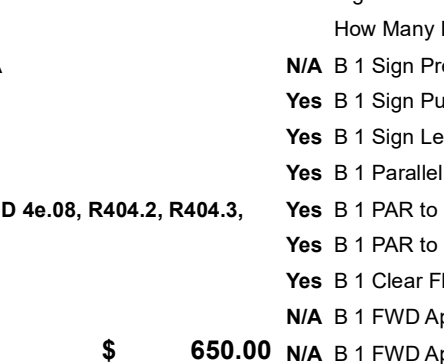
APS Compliance		MUTCD Compliance	
Is Button 1 APS or Non-APS?	NonAPS	Is Button 2 APS or Non-APS?	N/A
N/A B 1 VibroTact Arrow?	No	N/A B 2 VibroTact Arrow?	N/A
N/A B 1 VibroTact Parallel to Xing?	No	N/A B 2 VibroTact Parallel to Xing?	N/A
N/A B 1 VibroTact Contrast	No	N/A B 2 VibroTact Contrast	N/A
N/A B 1 Pilot Light?	No	N/A B 2 Pilot Light?	N/A
N/A B 1 Pilot Light Illumination?	No	N/A B 2 Pilot Light Illumination?	N/A
N/A B 1 Verbal Walk Cycle?	No	N/A B 2 Verbal Walk Cycle?	N/A
N/A B 1 Verbal Message Audible?	No	N/A B 2 Verbal Message Audible?	N/A
N/A B 1 Locator Tone?	No	N/A B 2 Locator Tone?	N/A
N/A B 1 Percussive Walk Cycle?	No	N/A B 2 Percussive Walk Cycle?	N/A
N/A B 1 Extended Press Feature?	No	N/A B 2 Extended Press Feature?	N/A
N/A B 1 Tone Audible Range?	No	N/A B 2 Tone Audible Range?	N/A
MUTCD Compliance		MUTCD Compliance	
Yes B 1 Clear Xing Direction?	ClearlyMarked	N/A B 2 Clear Xing Direction?	N/A

B 1 Crossing Direction	To NW	B 2 Crossing Direction	N/A
Yes B 1 DistanceTo XWalk (in)	15.0	N/A B 2 DistanceTo XWalk (in)	N/A
No B 1 DistanceTo Curb (in)	77.0	N/A B 2 DistanceTo Curb (in)	N/A
Yes B 1 Diameter (in)	2.0	N/A B 2 Diameter (in)	N/A

Possible Solutions: Replace Signal Push Button With APS Button on New Post. Remove & Relocate Sign.	
		Surveyor Notes: N/A	
		PROW/ADA: TMUTCD 4e.08, R404.2, R404.3, R404.7.3	
		Total Cost: \$ 650.00
